September 28, 2020

Re: Appeal of the Initial Decision Regarding the Request for Correction to NIST's Final Report on the Collapse of World Trade Center Building 7 (Information Quality #20-01)

Part 1: NIST’s Computer Simulations

Figure 8–21. Seat connection at Column 79. Exaggerated distance and angle of Girder A2001 in relation to Column 79

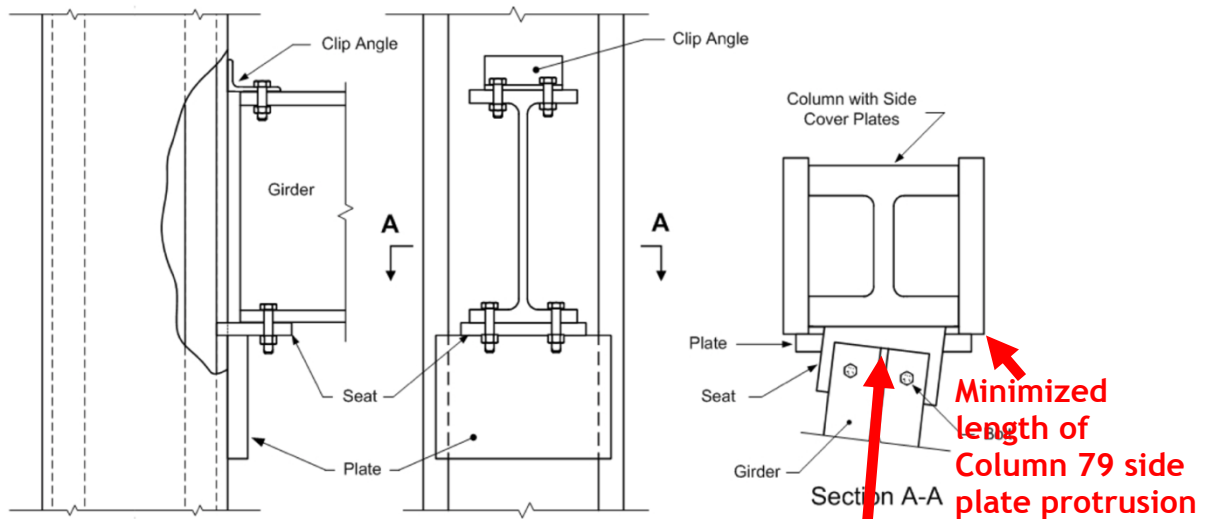
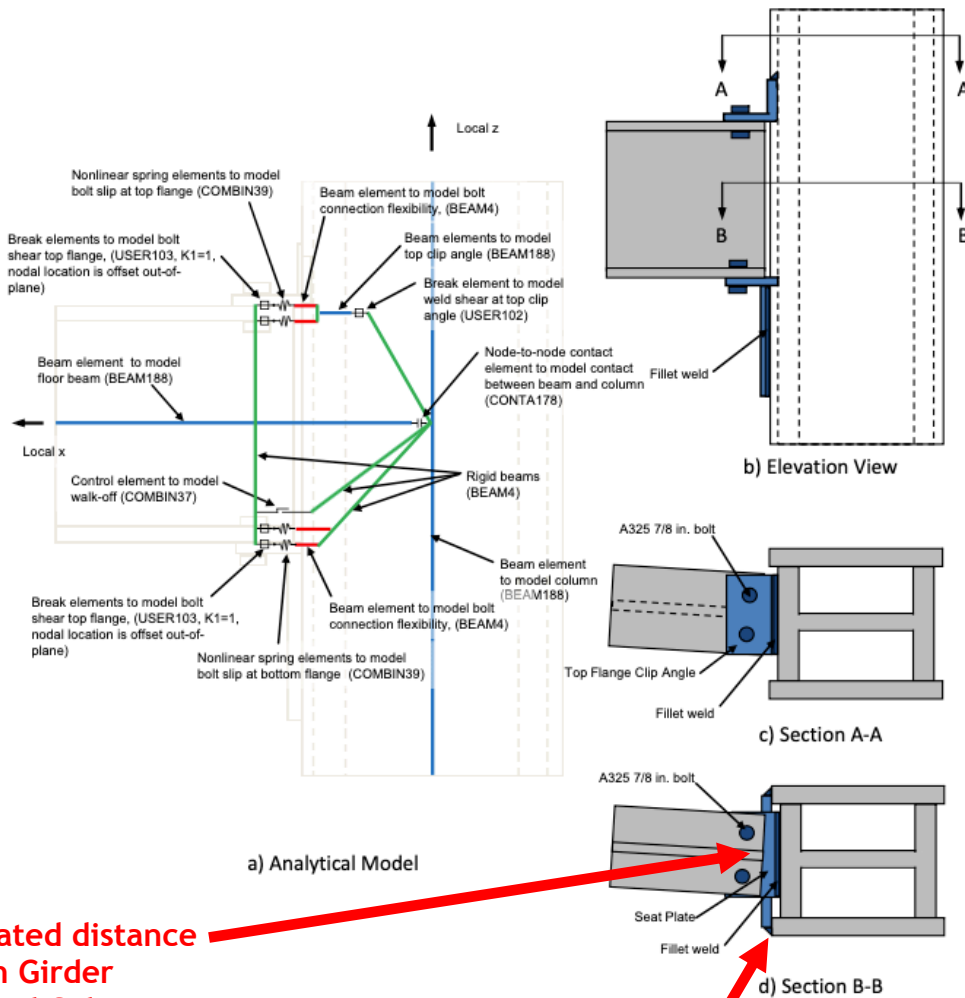
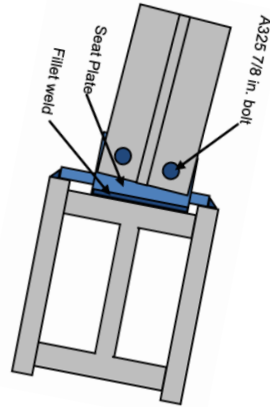
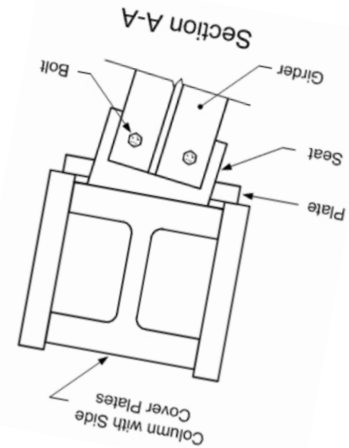
As noted above, Figures 8-21 and 11-5, which are shown below, only show the position of Girder A2001 in relation to Column 79 at room temperature and not at elevated temperatures. Furthermore, Figures 8-21 and 11-5 have the potential to mislead because they are not drawn to scale. As shown below, comparing Figures 8-21 and 11-5 to a figure that is drawn to scale (*see* Brookman 2012, p. 7) demonstrates that Figures 8-21 and 11-5 exaggerate the distance between Girder A2001 and Column 79 and minimize the length of the Column 79 side plate protrusion, and that Figure 8-21 also exaggerates the angle of Girder A2001 in relation to Column 79.

**Exaggerated distance
between Girder
A2001 and Column 79**

**Actual length of
Column 79 side
plate protrusion**

**Actual distance and
angle of Girder A2001 in
relation to Column 79**

By merely making general assertions about the validity of its 16-story ANSYS model and merely describing the position of Girder A2001 in relation to Column 79 at room temperature, the Initial Decision completely avoids discussing the behavior of Girder A2001 when it and the adjoining northeast floor beams are heated to the elevated temperatures at which NIST alleges the initiating failure occurred, thus failing to respond to the relevant data quality arguments contained in Section A.

1. Revise the NIST WTC 7 Report to reflect that the Column 79 side plate would have prevented Girder A2001 from moving westward enough to walk off its support at Column 79. NIST must then discard its Probable Collapse Sequence and develop a new Probable Collapse Sequence that is physically possible; or

Figure 8-26. Lateral displacement of girder due to thermal expansion of floor beam.
Note: failed bolts and shear studs

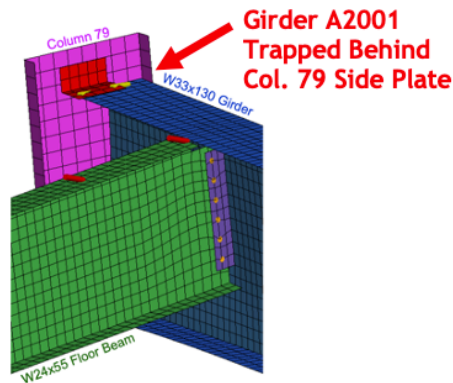
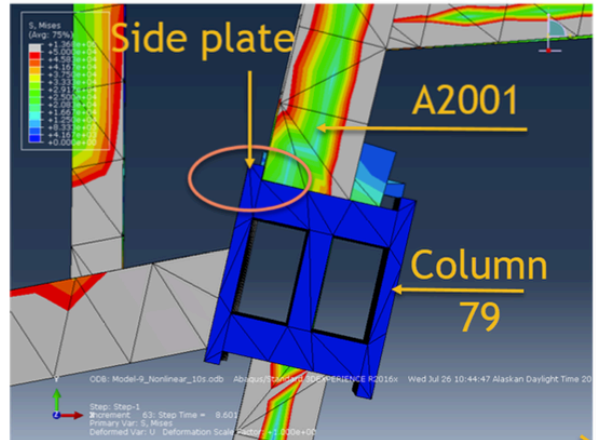
1. Preliminary analysis conducted by NIST using LS-DYNA software, presented in Section 8.8 of NCSTAR 1-9, as well as analysis conducted at the University of Alaska Fairbanks (UAF) using ABAQUS software, demonstrates that when Girder A2001 and the adjoining floor beams are heated according to NIST's assumptions (to 500 °C and 600 °C, respectively), Girder A2001 expands and becomes trapped behind the side plate on the western side of Column 79 as it is pushed to the west by the thermally expanding floor beams. The trapping of Girder A2001 behind the Column 79 side plate in NIST's preliminary LS-DYNA analysis is illustrated graphically in Figure 8-26 of Section 8.8 shown below. The trapping of Girder A2001 behind the Column 79 side plate in the UAF analysis is illustrated graphically in Figure 3.4 of the UAF Report shown below.

2. Contradicting the finding of its preliminary LS-DYNA analysis that Girder A2001 would become trapped behind the side plate on the western side of Column 79 — a finding corroborated by the UAF analysis — NIST somehow ultimately concludes that “the floor beams on the east side of the building expanded enough that they pushed the girder spanning between Columns 79 and 44 to the west on the 13th floor. . . . This movement was enough for the girder to walk off of its support at Column 79.” (See NCSTAR 1A, p. 22. Emphasis added.) Yet the NIST WTC 7 Report provides no analysis, calculations, or figures explaining how Girder A2001 moved westward past the Column 79 side plate enough for it to walk off of its support at Column 79 in its 16-story ANSYS model.

4. In summary, NIST's preliminary LS-DYNA analysis and the UAF analysis demonstrate that Girder A2001 would have become trapped behind the Column 79 side plate when heated according to NIST's assumptions. Thus, the first major step leading to the initiating local failure in NIST's Probable Collapse Sequence — the walk-off of Girder A2001 — was physically impossible. Furthermore, the NIST WTC 7 Report does not provide any analyses, calculations, or figures sufficient to demonstrate that Girder A2001 could have moved past the Column 79 side plate enough to walk off its support at Column 79. Thus, we deduce that NIST's 16-story ANSYS model ignored the effect that Column 79's side plate would have had in preventing the walk-off of Girder A2001.

Figure 11–48. Floor 13 Case B temperatures at 3.5h to 4.0 h.

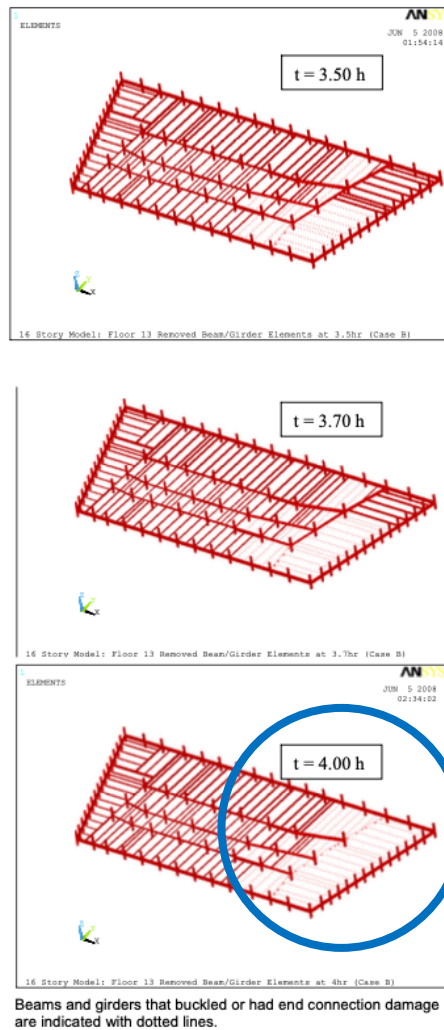
In addition, NIST’s reference to Figure 11-48 (shown below) does not address the central claim nor the underlying relevant data quality arguments contained in Section B, because Figure 11-48 merely identifies which beams and girders buckled or had connection end damage in NIST’s analysis. It does not actually explain or illustrate how beam K3004 expanded sufficiently to make Girder A2001 walk off of its support at Column 79.

Figure 11-48 merely identifies that Girder A2001’s connection at Column 79 failed in NIST’s 16-story ANSYS model. It does not explain how beam K3004 expanded sufficiently to make Girder A2001 walk off its support at Column 79.

1. Revise the NIST WTC 7 Report to reflect that beam K3004 could not thermally expand enough to cause the walk-off of Girder A2001. NIST must then discard its Probable Collapse Sequence and develop a new Probable Collapse Sequence that is physically possible; or

Figure 1–5. Typical WTC 7 floor showing locations of the columns, girders, and beams.

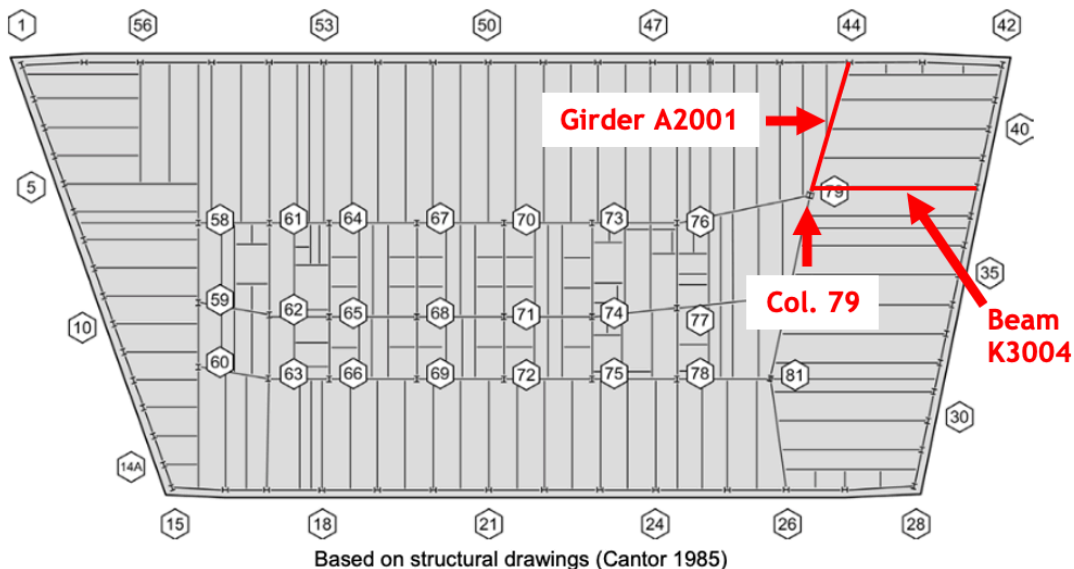
1. Beam K3004 was the closest beam to Column 79 framing into Girder A2001 from the east. Therefore, the thermal expansion of beam K3004 dictated the extent of westward displacement of Girder A2001 at Column 79. Beam K3004 (along with Girder A2001 and Column 79) is indicated in Figure 1-5 of NCSTAR 1-9 below.

- a. As an addendum to this point, it should be noted that — when NIST states in its Initial Decision that “all the floor beams had connections to the Girder and expanded against Girder A2001 until the connection at Col 79 failed” — NIST effectively confirms that the connection between beam K3004 and Girder A2001 did not break in its 16-story ANSYS model. NIST’s confirmation that this connection did not break is relevant because had the connection broken, the thermal expansion of beam K3004 would no longer dictate the extent of westward displacement of Girder A2001 at Column 79. But as long as that connection was intact, beam K3004 would continue to dictate the extent of westward displacement of Girder A2001 at Column 79. The expansion of the other northeast beams could cause Girder A2001 to bend, but the end of Girder A2001 could move only as far as beam K3004 expanded.

Figure 8-26. Lateral displacement of girder due to thermal expansion of floor beam.
 Note: failed bolts and shear studs

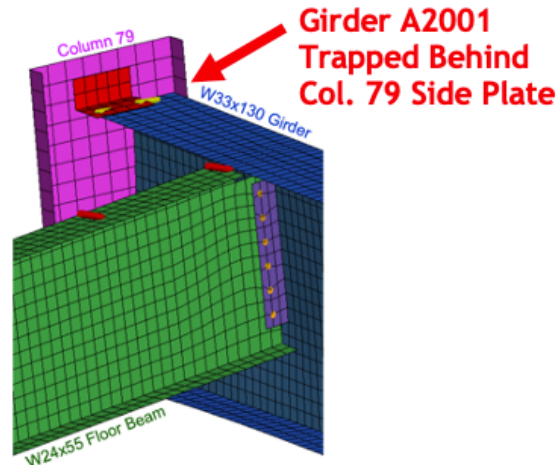
A primary reason that flange bending does not occur in the preliminary LS-DYNA analysis is that — as discussed in Section A — Girder A2001 becomes trapped behind the Column 79 side plate and therefore is not pushed westward at least 6.25 inches to where the web of Girder A2001 is no longer supported by the bearing seat. In other words, in the preliminary

LS-DYNA analysis, Girder A2001 was not pushed into a position where bending of the girder flange followed by walk-off could occur. The trapping of Girder A2001 behind the Column 79 side plate is illustrated in Figure 8-26 shown below (the same figure cited in Section A).

However, in the 16-story ANSYS model, Girder A2001 was pushed into a position where bending not only could occur (if the girder were pushed far enough and had no web stiffeners), but where it would need to occur in order for Girder A2001 to walk off its support at Column 79. The fact that flange bending did not occur in the preliminary LS-DYNA analysis is totally irrelevant, because Girder A2001 was not pushed into the same position it was pushed into in the 16-story ANSYS model.

1. Perform new analyses that include the partial height web stiffeners on Girder A2001 and revise the NIST WTC 7 Report to reflect that Girder A2001 would not have walked off its support at Column 79. As noted in the Request, there is no reasonable basis for not performing these new analyses since NIST has acknowledged it omitted the web stiffeners from its analyses, NIST's justification for omitting the web stiffeners is irrational, and this omission has been shown to have materially affected the results of NIST's analyses. NIST must then discard its Probable Collapse Sequence and develop a new Probable Collapse Sequence that is physically possible; or

Figure 3.8 Analysis showing girder web A2001 pushed laterally past the bearing seat at Column 79. The column is removed for clarity.

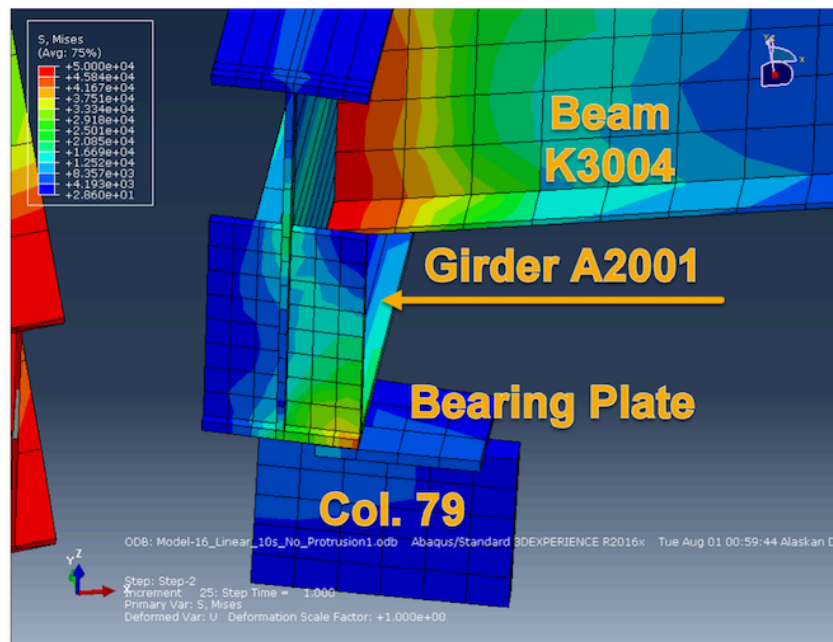
2. NIST’s stated reason for omitting the web stiffeners from its analyses is fundamentally unsound. As noted in the UAF Report, “In addition to stiffening the web, these stiffeners significantly increase the bending resistance of the flange and would have prevented it from failing due to flexure (assuming the girder were somehow able to bypass the column side plate).” (See UAF Report, p. 81.) As illustrated in Figure 3.8 of the UAF Report, shown below, the stresses in the girder flange and stiffener are not sufficient to cause the flange to fail, and thus Girder A2001 would not have walked off its support at Column 79 when pushed westward 6.25 inches. (See UAF Report, p. 82.)

3. The NIST WTC 7 Report provides no analysis, calculations, or figures explaining how Girder A2001 actually walked off of its support at Column 79 in its 16-story ANSYS model. As noted in the previous section, the NIST WTC 7 Report merely states in general terms (see NCSTAR 1-9, p. 527): “A girder was considered to have lost vertical support when its web was no longer supported by the bearing seat. The bearing seat at Column 79 was 11 in. wide. Thus, when the girder end at Column 79 had been pushed laterally at least 5.5 in., it was no longer supported by the bearing seat.”¹ Moreover, NIST does not address the omission of the Girder A2001 web stiffeners either in the NIST WTC 7 Report or in the NIST WTC 7 FAQs.

Figure 11–34. Damage state of connections, beams, and girders in Floor 12 at 4.0 h for Case B temperatures.

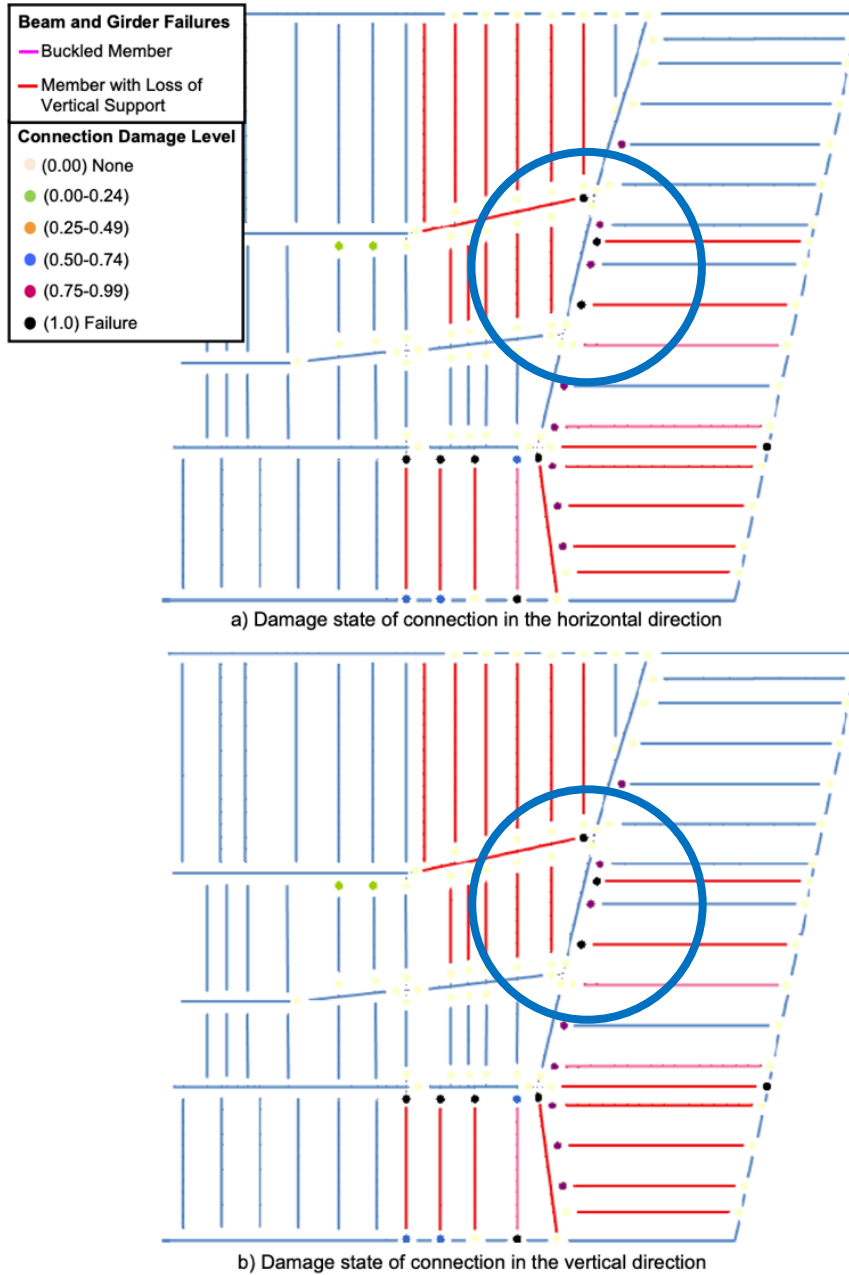
As an addendum to the relevant data quality arguments from the Request listed above, it must also be noted that the fire-induced damage at 4 hours of heating in NIST’s 16-story ANSYS model, which NIST cites in the Initial Decision, does not help explain how the impact load of Floor 13 falling onto Floor 12 would be sufficient to cause Floor 12 to fail (presumably by breaking the girder connection of Floor 12’s Girder A2002 on the south side of Column 79). As shown in Figure 11-34 of NCSTAR 1-9 below, Floor 12’s Girder A2002 and its connections to both Column 79 and Column 80 were undamaged. Therefore, the calculation presented above of the force required to shear the undamaged Girder A2002 connection at Column 79 applies fully.

1. Revise the NIST WTC 7 Report to include calculations that demonstrate that the impact load of Floor 13 falling onto Floor 12 would be insufficient to cause Floor 12 to fail. NIST must then discard its Probable Collapse Sequence and develop a new Probable Collapse Sequence that is physically possible; or

Figure 11-35. Damage state of connections, beams, and girders in Floor 13 at 4.0 h for Case B temperatures.

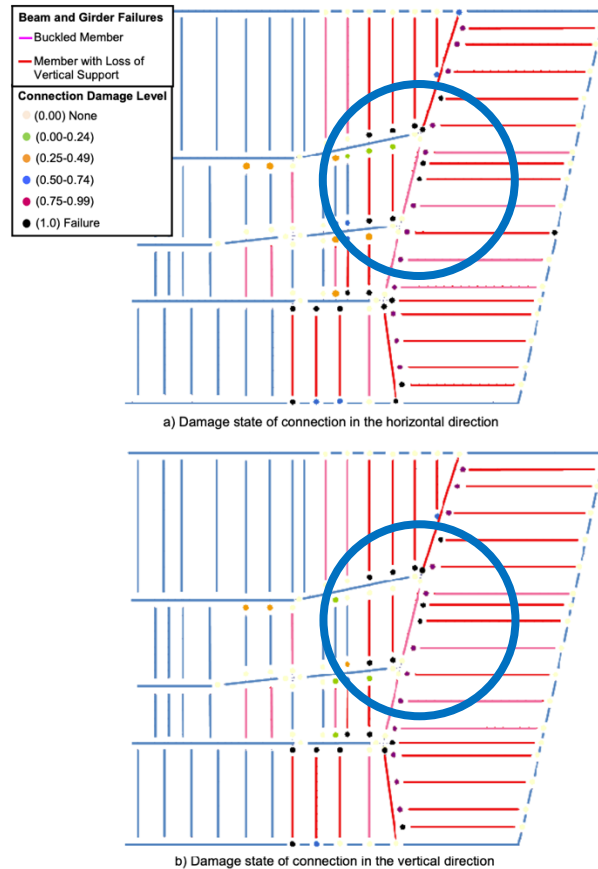
Contradicting the above claims, as shown in Figures 11-35 of NCSTAR 1-9 below, NIST’s 16-story ANSYS model shows that Girder A2002 on Floor 13 had buckled but did not have connection damage. It must be noted that the buckled Girder A2002 on Floor 13 would still provide sufficient lateral support to Column 79. Girder A2002’s buckling load was 242,000 lbs. Assuming Girder A2002’s axial strength was reduced by 50% once buckled, it would still withstand 122,000 lbs. in compression. The lateral support requirement for a column is approximately 0.6% of the column’s axial load. Column 79 was ASTM A572 GR 50 steel with a 50 ksi yield strength. It had a cross section of 319 in² at Floor 13 and a factor of safety of about 3. Therefore, it would have had about $50,000/3 \times 319 = 5.32 \times 10^6$ lbs. on it at Floor 13, and 0.6% of that is about 32,000 lbs. — which is substantially less than the axial strength of the buckled Girder A2002.

In short, based on the fire-induced damage estimates in NIST’s 16-story ANSYS model, there is no apparent basis for concluding that Girder A2002 lost vertical support on Floors 12 and 13. Moreover, as the NIST WTC 7 Report notes, the east floor beams provided lateral support in the east-west direction as long as the girders were intact (*see* NCSTAR 1-9, p. 531):

Therefore, as long as Girder A2002 did not lose vertical support, beam D3004 (the northern most east floor beam south of Column 79) would provide lateral support in the east-west direction. Together, these observations preclude the reported cascade of floor failures and loss of lateral support in the east-west and south directions between Floors 5 and 14.

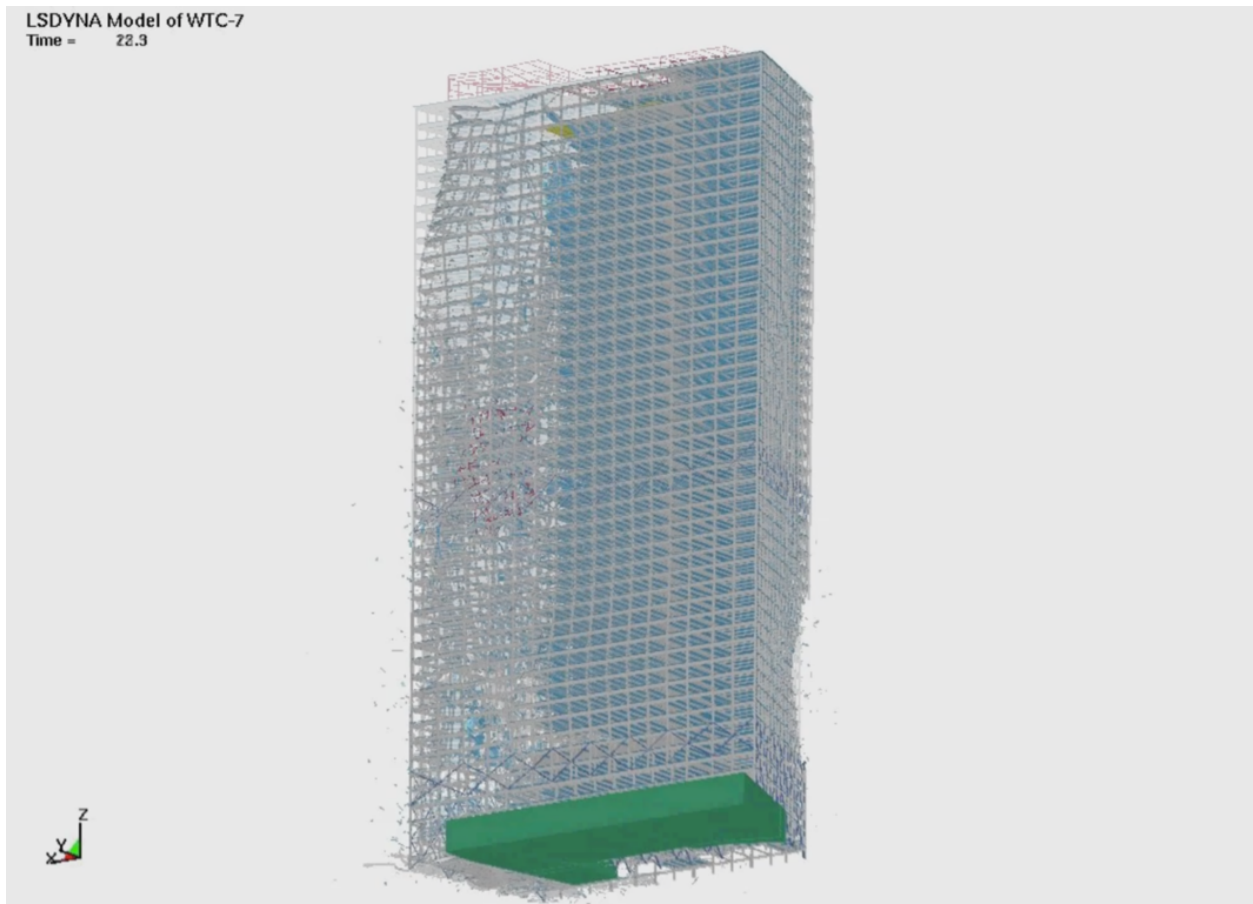
This claim is patently false. As illustrated very clearly in the Request, substantial deformation of the upper exterior walls occurred **prior** to the initiation of global collapse in NIST's global collapse analysis while none whatsoever is seen in the video images. Figure 2 from the Request, shown below, presents the animation of the global collapse analysis at 6.3 seconds after the initiation of the east penthouse collapse, laid over the animation at .1 seconds before the initiation of the east penthouse collapse. 6.3 seconds is the time that NIST identifies as the initiation of global collapse in its model. Thus, the two stills from the animation illustrate the change that occurred between the initiation of the east penthouse collapse and the initiation of global collapse. As is readily apparent in Figure 2, substantial deformation of the upper exterior walls occurred prior to the initiation of global collapse in NIST's global collapse analysis. The NIST WTC 7 Report acknowledges that “In both analyses, the eastern exterior wall deflected inward at the roof level as the structure became unsupported after the vertical collapse event [i.e., global collapse].” (See NCSTAR 1-9, p. 600.) In fact, the inward deflection of the eastern exterior wall in NIST's global collapse analysis commences well before the initiation of global collapse.

The Initial Decision completely ignores this analysis from Section E and simply restates the claim in NIST WTC 7 FAQ #35, which this analysis unambiguously refutes.

1. Revise the NIST WTC 7 Report to reflect that the north face roofline underwent a sudden transition to free fall, as shown in detail from page 35 to 39 of the Request. Then perform a new global collapse analysis that both is physically possible (i.e., does not involve the walk-off of Girder A2001 at its Column 79 support nor a cascade of floor failure from Floor 13 to Floor 5) and matches the observed behavior well (e.g., the scenario simulated in the UAF analysis). Then discard the Probable Collapse Sequence and adopt a new probable collapse sequence that both is physically possible and better matches the observed behavior; or
